**GENOA CHARTER TOWNSHIP
PLANNING COMMISSION
PUBLIC HEARING
JANUARY 12, 2015
6:30 P.M.
AGENDA**

Attention:	Kelly Van Marter, AICP Assistant Township Manager and Planning Director
Subject:	The Well Worship Facility and Coffee Shop – Sketch Plan Review #1
Location:	2250 Genoa Business Park Drive – northwest corner of Grand River Avenue and Genoa Business Park Drive
Zoning:	GCD General Commercial District

Attention:	Kelly Van Marter, AICP Assistant Township Manager and Planning Director
Subject:	Redevelopment of Livingston Commons Lot #4 – Site Plan Review #2
Location:	Southwest corner of Grand River Avenue and Latson Road
Zoning:	NR-PUD Non-Residential Planned Unit Development District

Re: Livingston Commons Lot 4 Redevelopment Site Plan Review # 2

BUILDING RENOVATION for:
THE WELL
GENOA TOWNSHIP, MICHIGAN
SCHEMATIC FLOOR PLAN

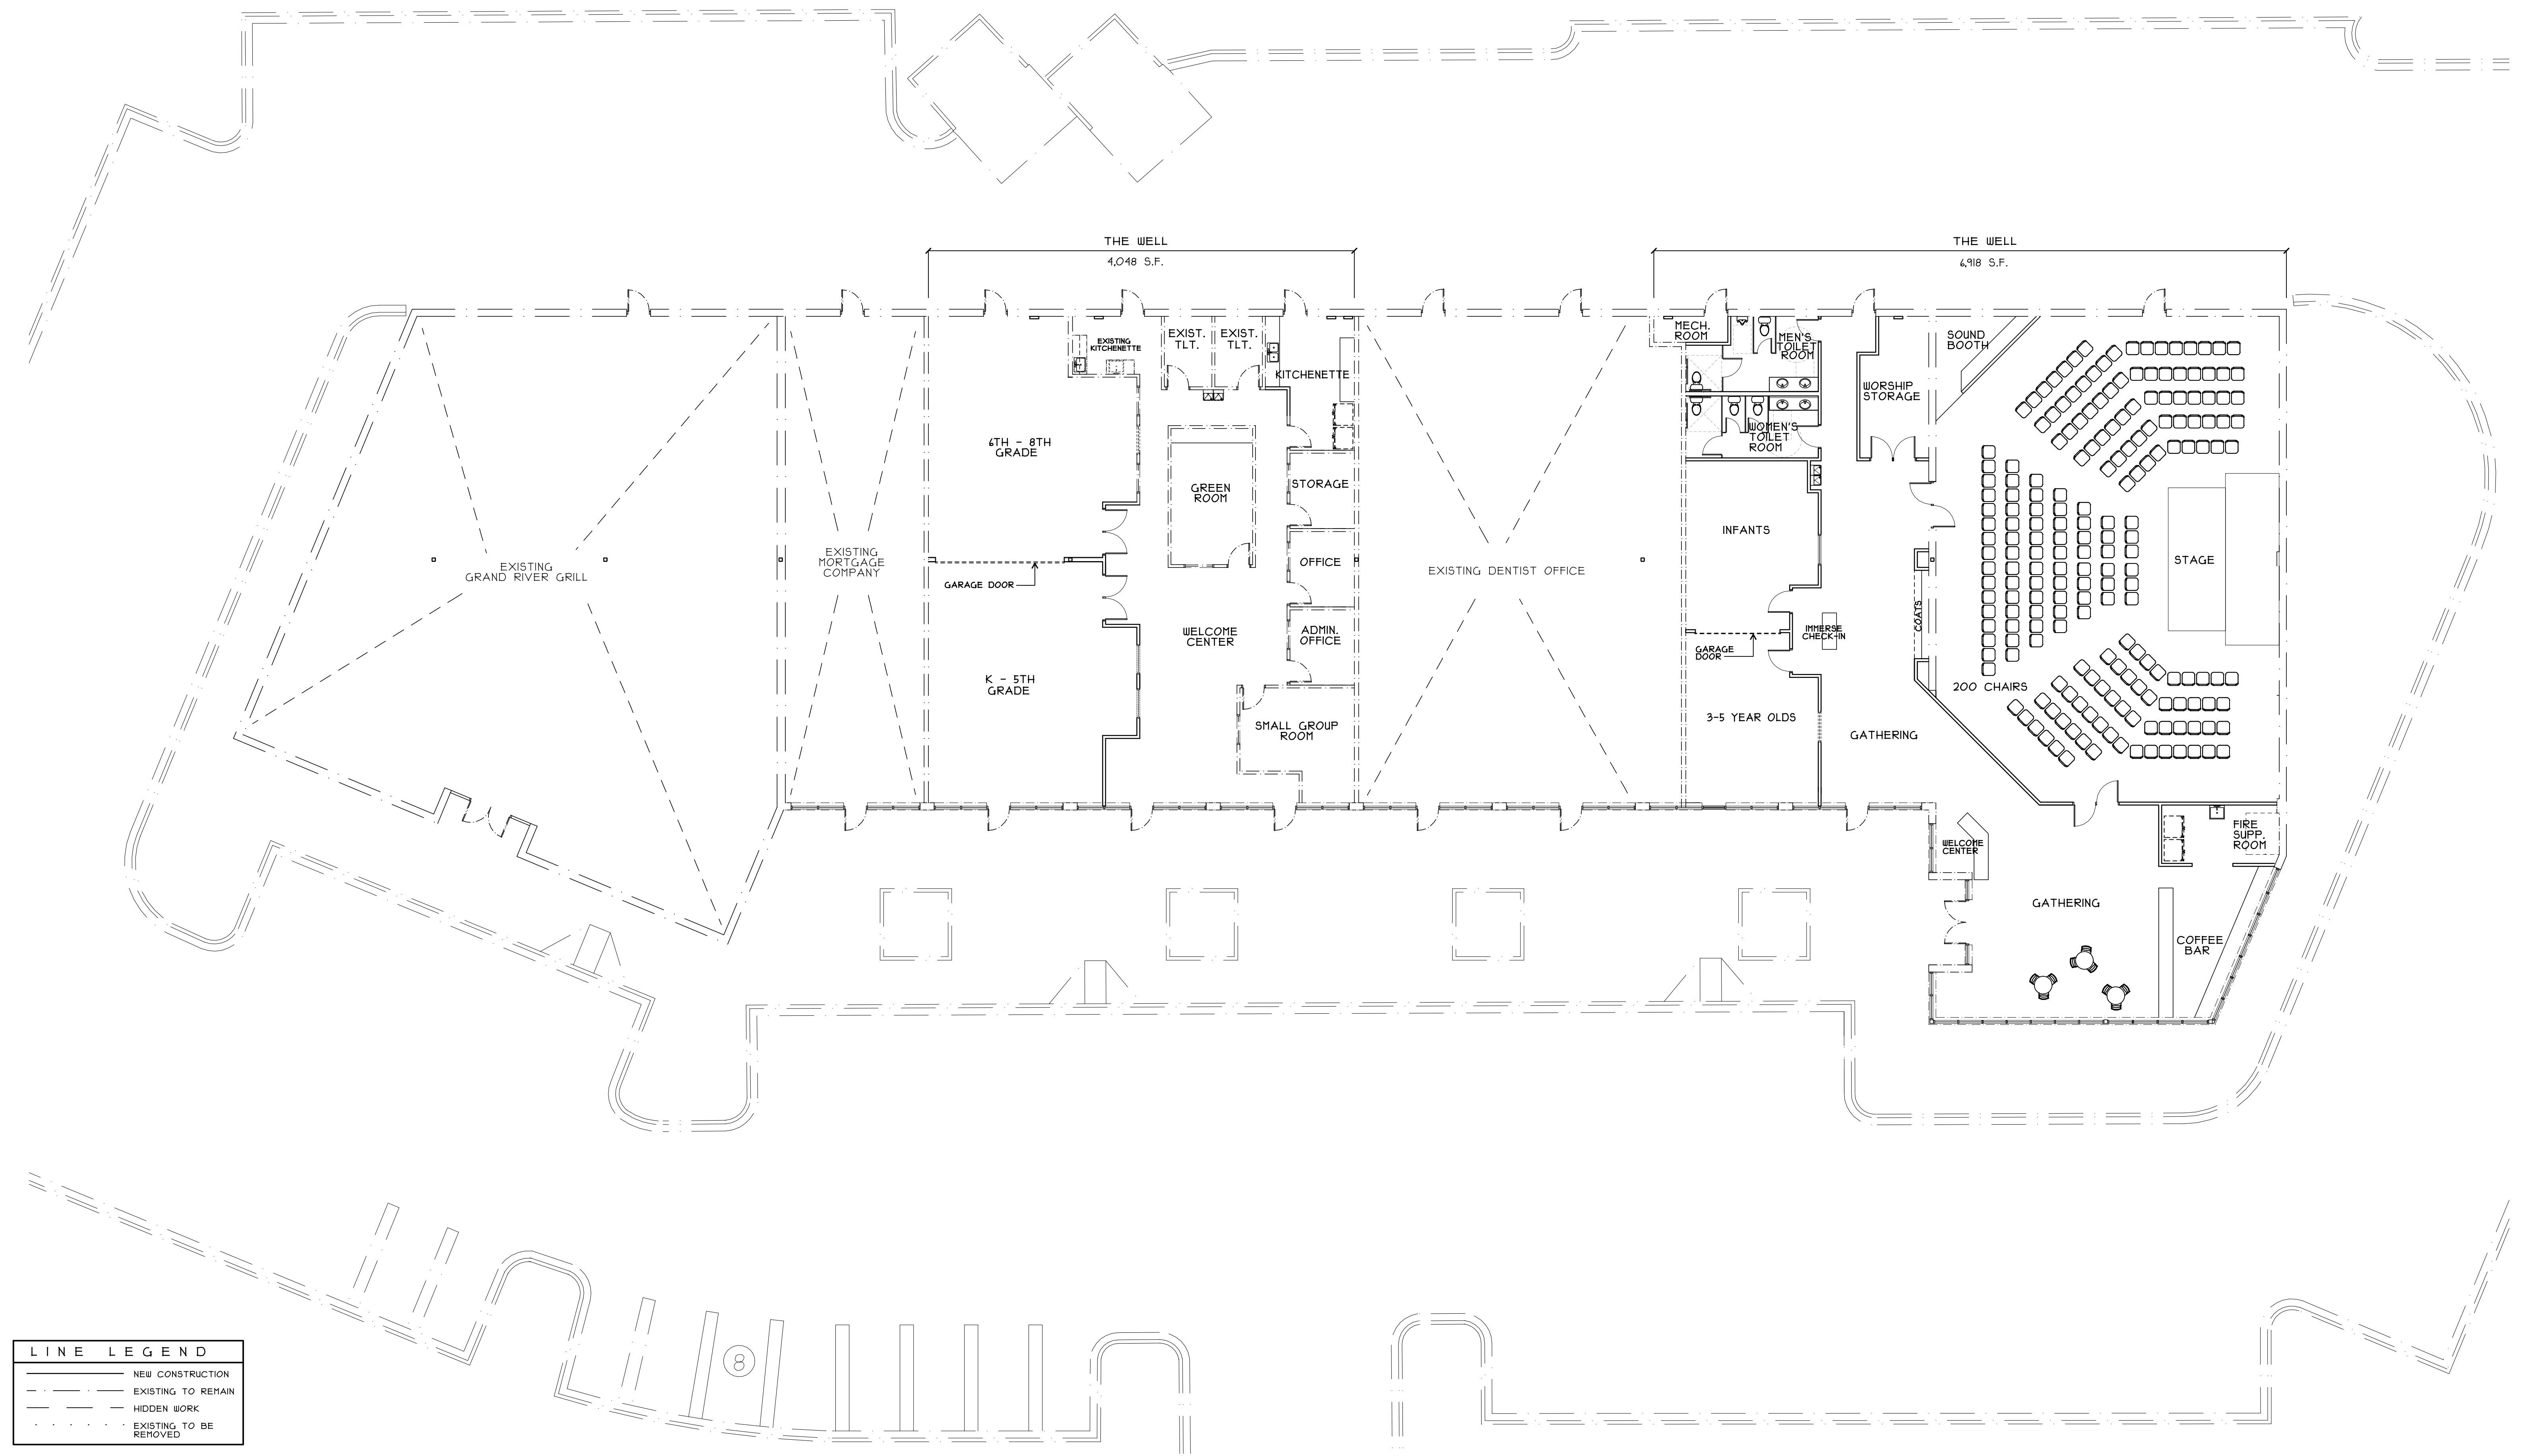
As requested, we have reviewed the sketch plan (dated 12/18/14) proposing a new use for two units in the existing retail center at 2250 Genoa Business Park Drive. Specifically, the applicant proposes a 6,918 square foot worship facility (including a 1,000 square foot coffee bar) and a 4,048 square foot youth ministry facility.

The submittal does not include a signed agreement, nor is any evidence provided supporting this arrangement. While one can reasonably assume that the peak usage of a church and office building will be at different periods, the applicant must provide documentation in support of this proposal.

SHEET C-2.0

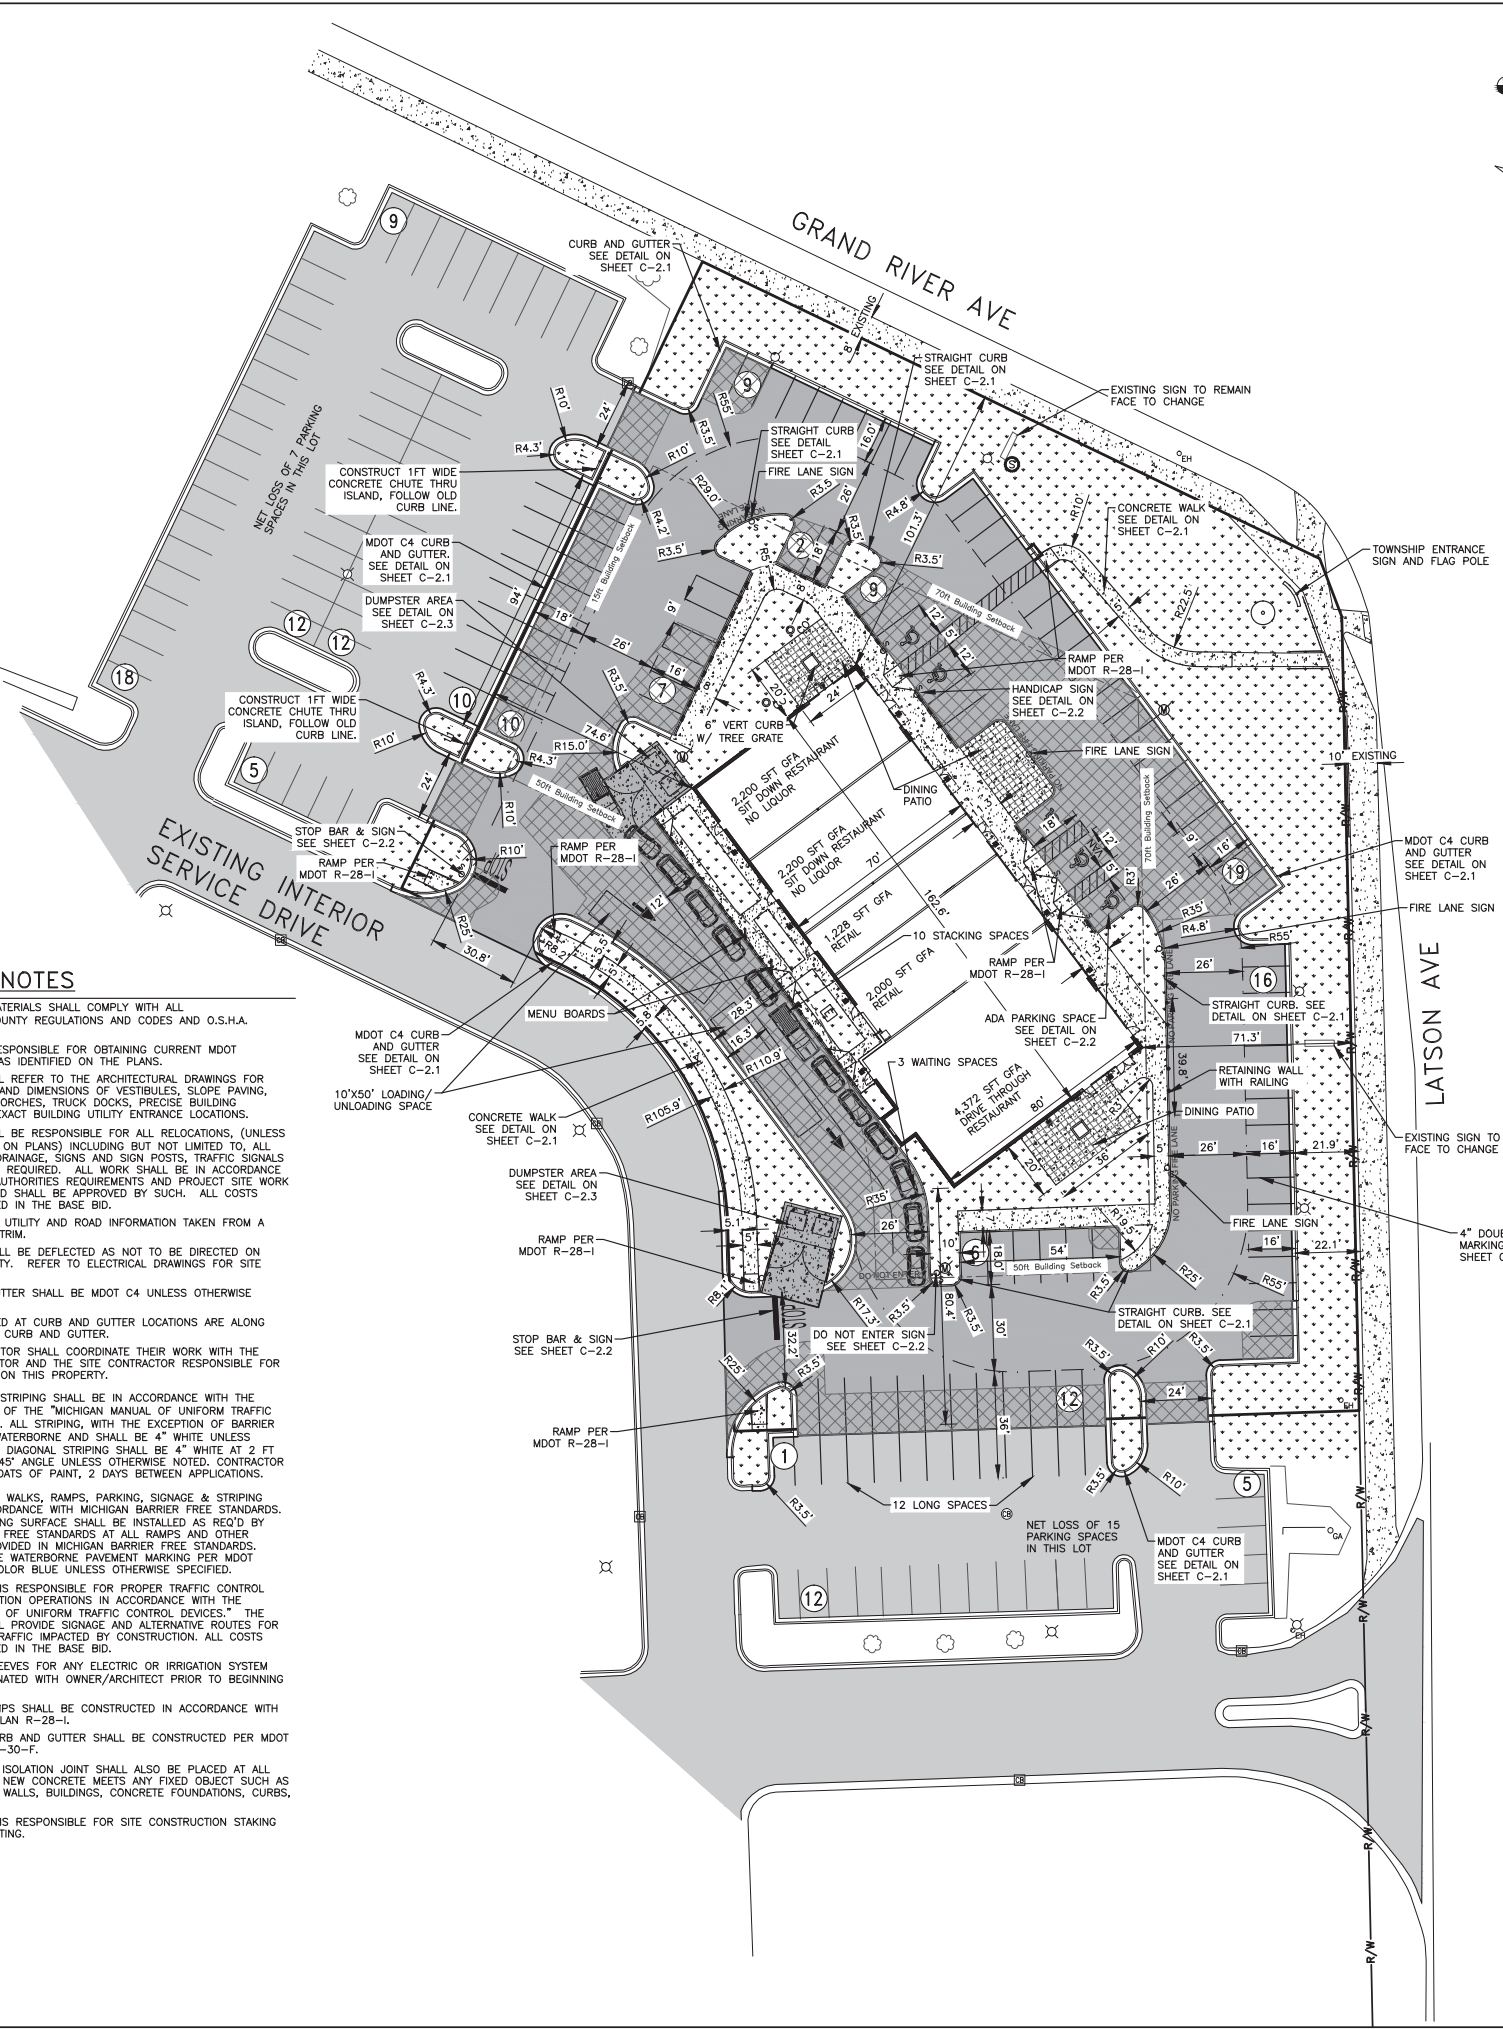
3. **Parking.** As outlined in the table on Sheet C-2.0, 120 spaces are required for the proposed multi-tenant building. Additionally, given the nature of the uses, 12 RV spaces, 3 waiting spaces and 10 stacking spaces are also required.

The parking spaces and drive aisles meet or exceed the dimensional standards of Section 14.06 and a note on Sheet C-2.0 indicates the use of looped (double striped) spaces.
